RE: **Lot 3 Block 3 Unit 22 SAD 228**
6328 Camino Alto NW
Volcano Cliffs Subdivision
Grading and Drainage Plan
Engineers Stamp Date 4/30/18 (D10D003R3)

RE: **Lot 3 Block 3 Unit 22 SAD 228**
6328 Camino Alto NW
Volcano Cliffs Subdivision
Grading and Drainage Plan
Engineers Stamp Date 4/16/18 (D10D003R3)

ENGINEER'S SEAL	Title	DRAWN BY
	6328 CAMINO ALTO NW	DATE
	GRADING AND DRAINAGE PLAN	Day
		SHEET #
		1 of 1
		JOB #

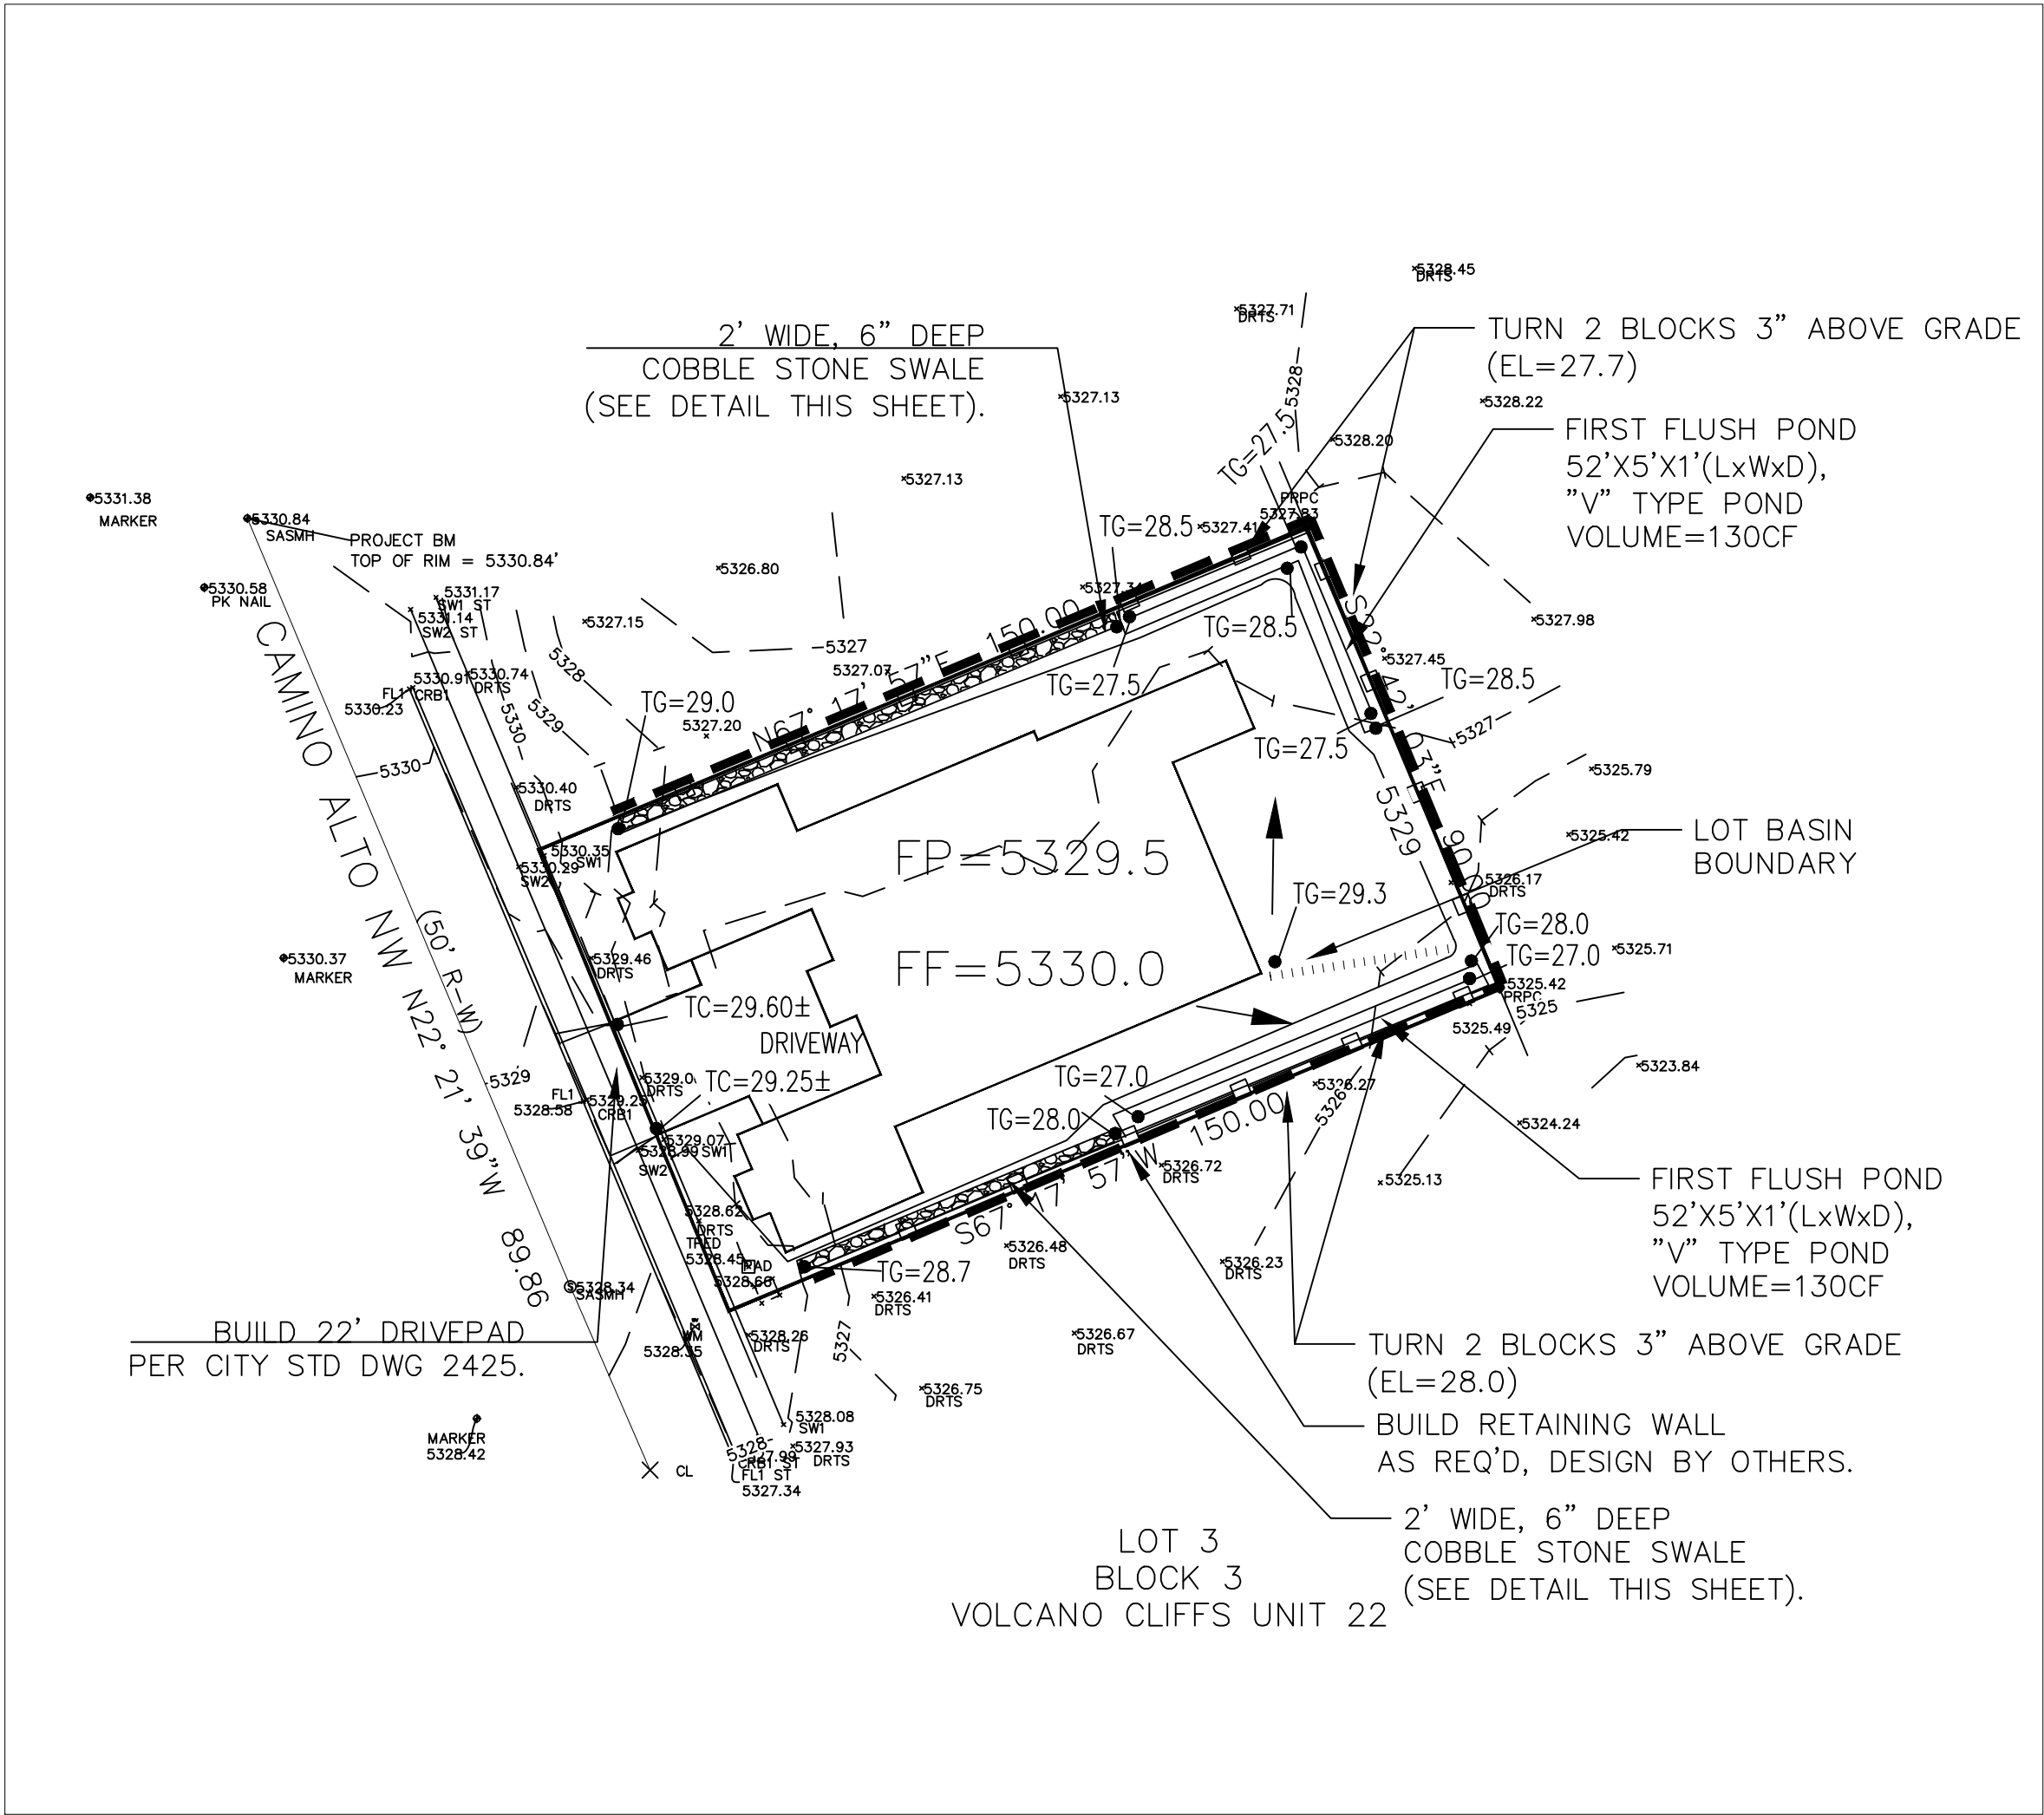
- Place turn blocks 3" above grade.
- Provide a note stating that a permit is required for the retaining wall and any future garden wall. This is the plan to follow dated 4/16/18 when applying for a perimeter block wall.
- Provide a cross section of the retaining walls showing location of wall pertaining to the lot lines. If encroaching into adjacent lots a written letter of approval from owners of the adjacent lots is required.

1. The note to turn blocks 3" above grade has been added.
2. The note regarding the garden wall/retaining wall has been added.
3. A cross section of the wall has been added.

- ANY GARDEN WALL/RETAINING WALL IS TO BE BUILT ON-SITE (DESIGN OF THE GARDEN WALL/RETAINING WALL IS BY OTHERS).
- A PERMIT IS REQUIRED FOR THE CONSTRUCTION OF THE RETAINING WALL AND ANY FUTURE GARDEN WALL. THIS IS THE PLAN TO FOLLOW (4-30-18) WHEN APPLYING FOR A PERIMETER BLOCK WALL.
